ADDENDUM NO. 2

Reference: UVU Student Life Center & Parking Structure
Orem, Utah
DFCM Project No. 10289790

STUDENT LIFE CENTER & PARKING STRUCTURE

The original specifications and drawings, dated April 27, 2012 for the project referenced above are amended in this Addendum No. 2, dated May 04, 2012.

A1 / SF-103a FLOOR & LOW ROOF FRAMING PLAN - LEVEL 3 ZONE A

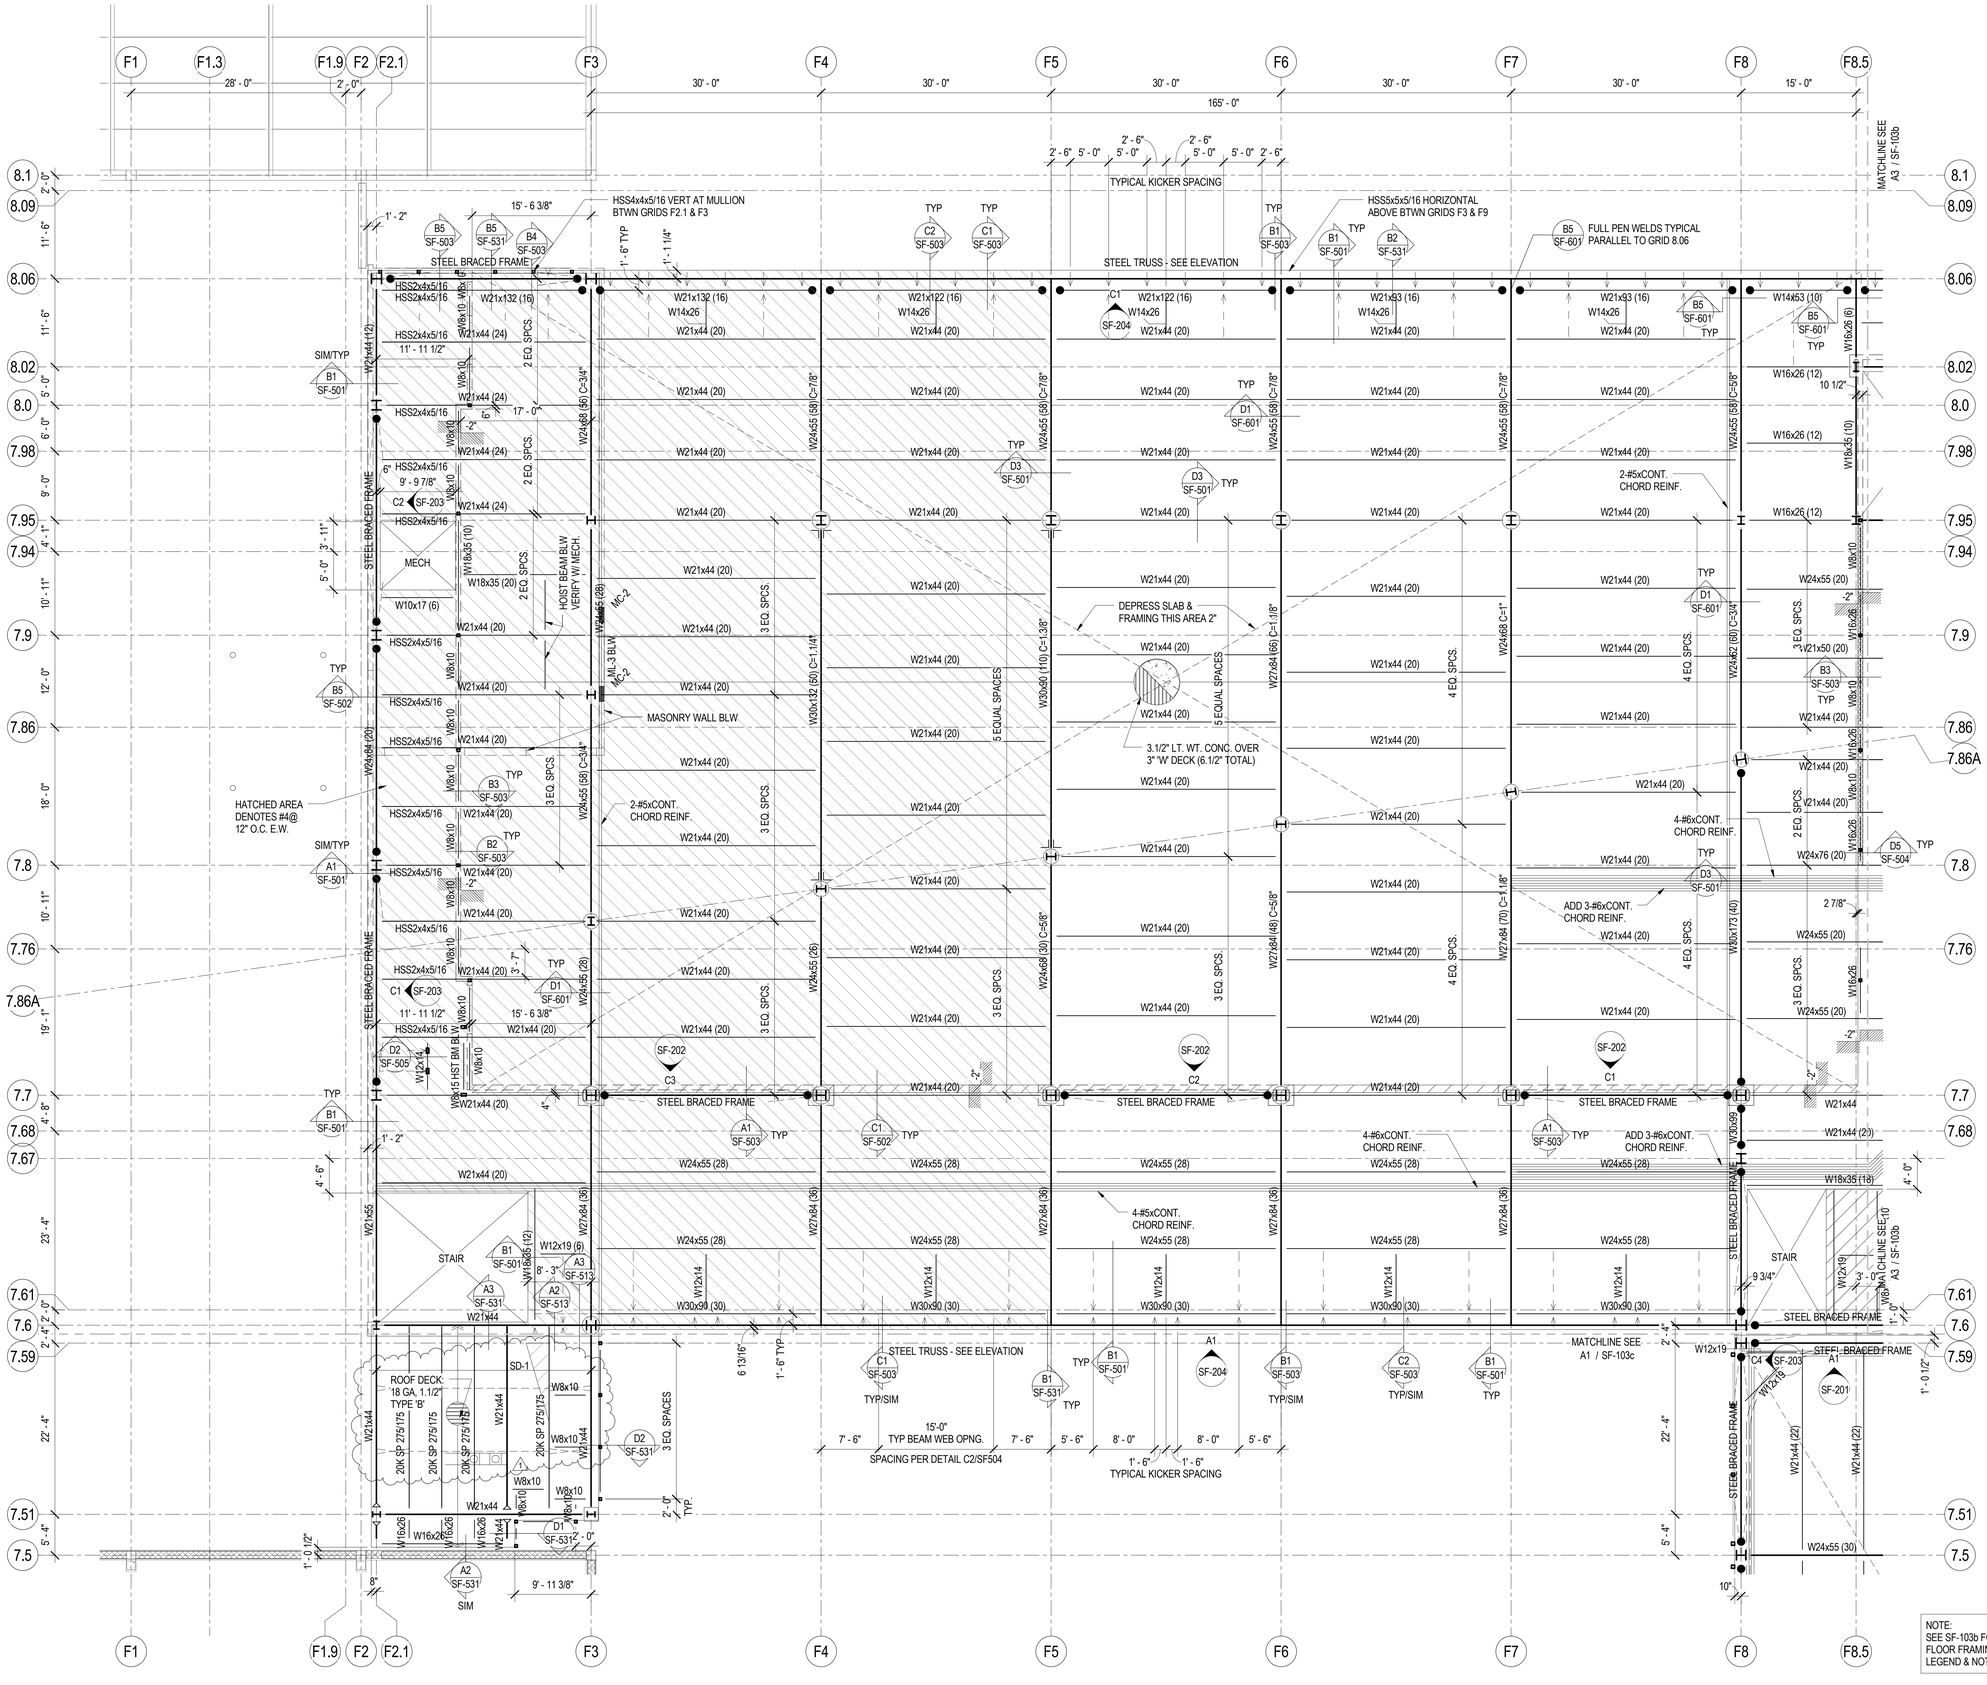
Sheets SF-103a:
1. See revised partial third floor and low roof framing plan area A.

A1 SF-105c ROOF FRAMING PLAN - LEVEL 5 ZONE C

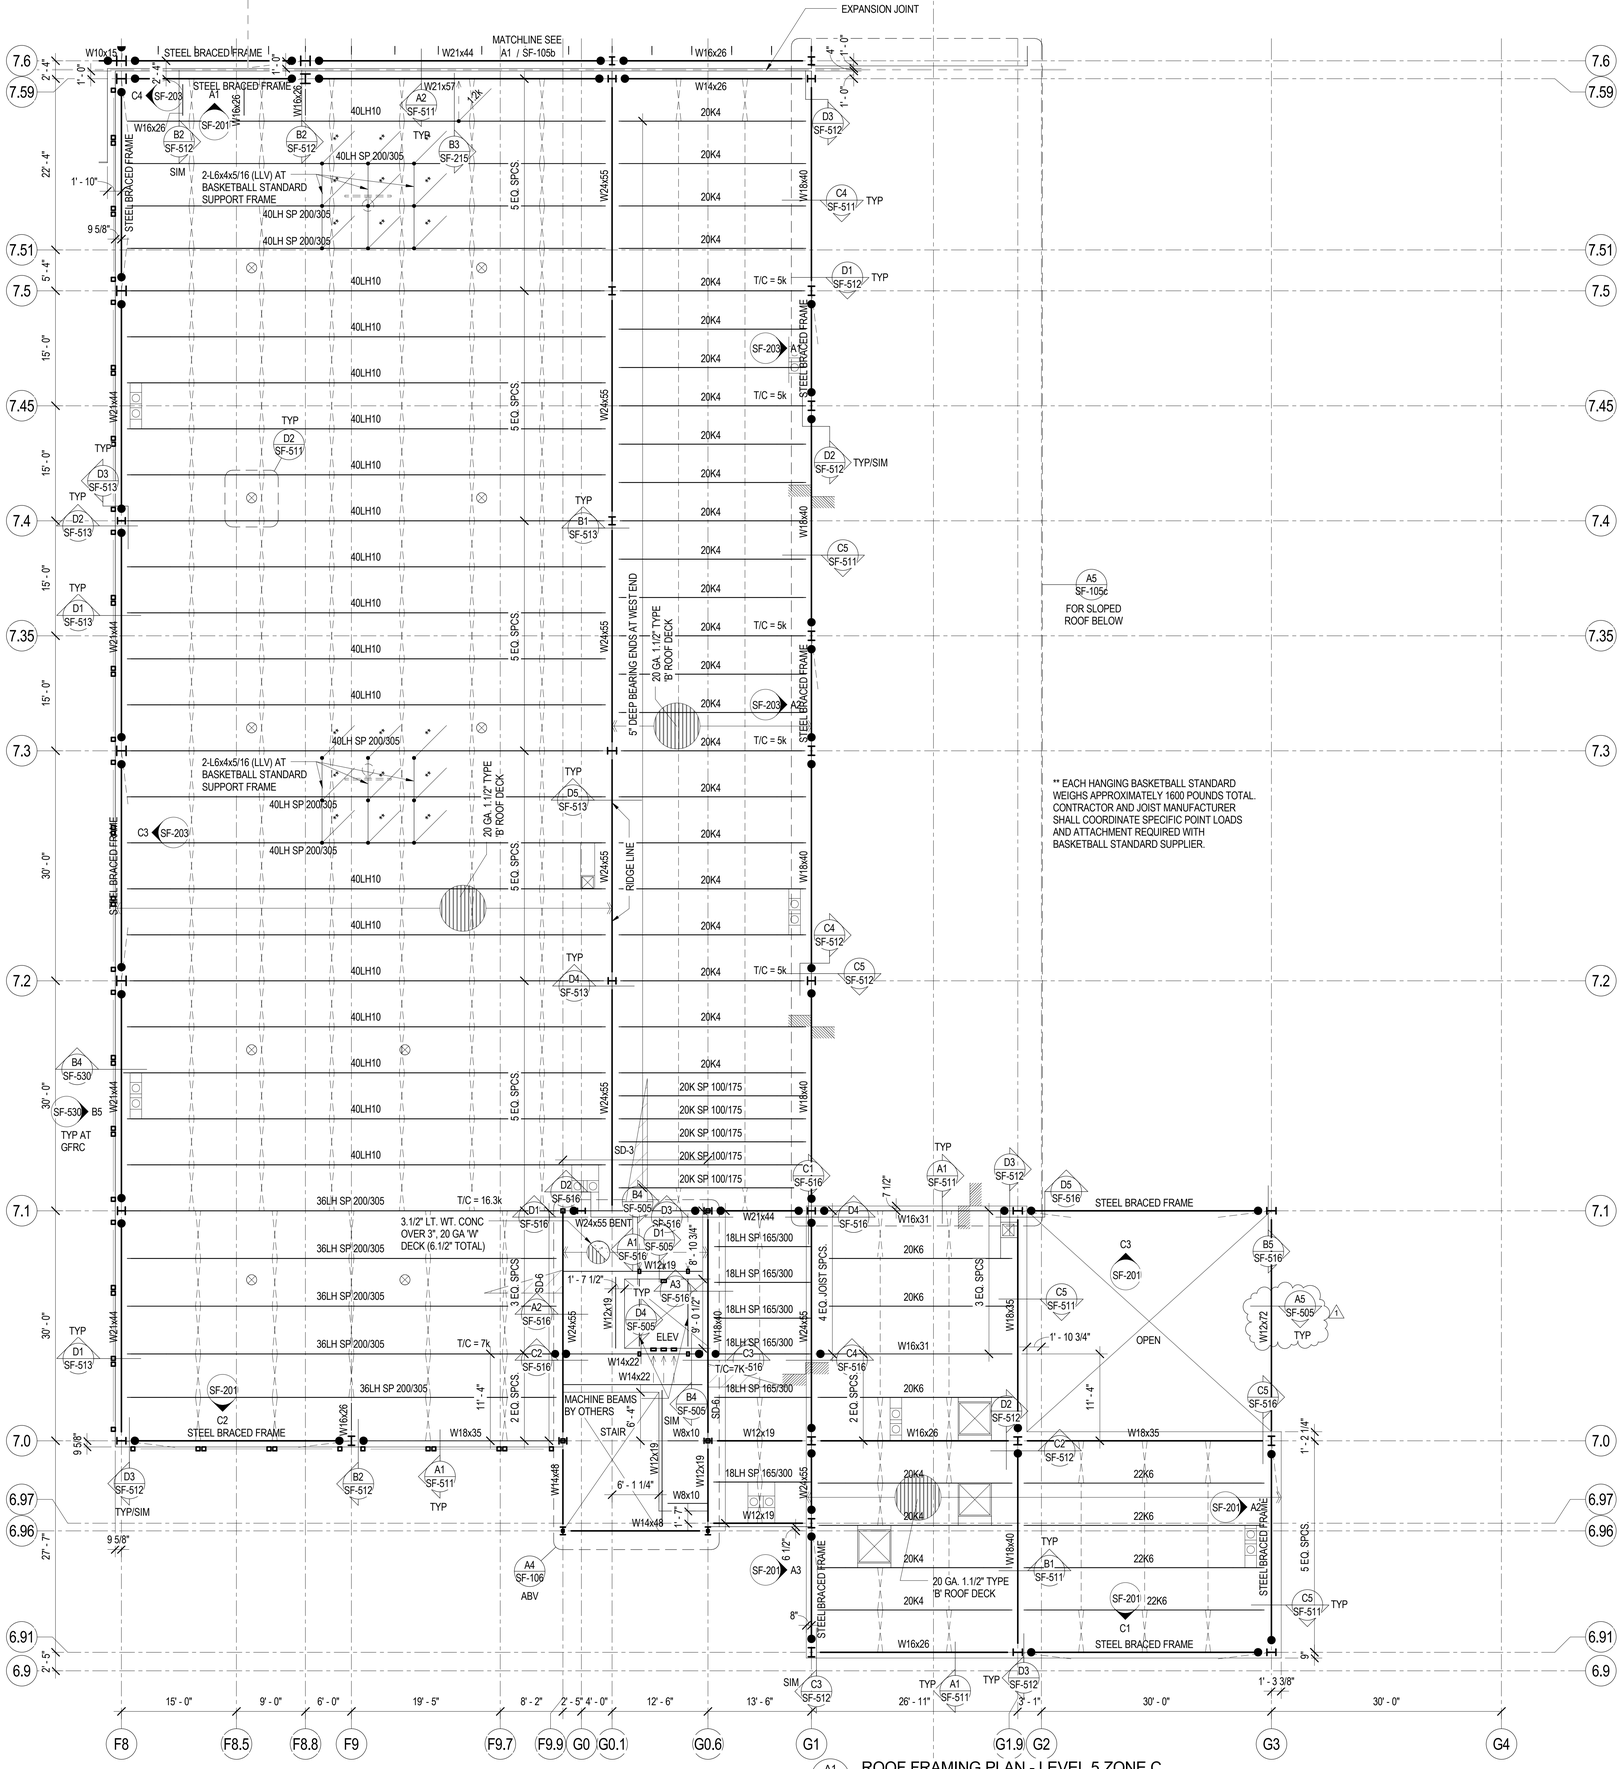
Sheets SF-105c:
1. See revised partial roof framing plan area C.
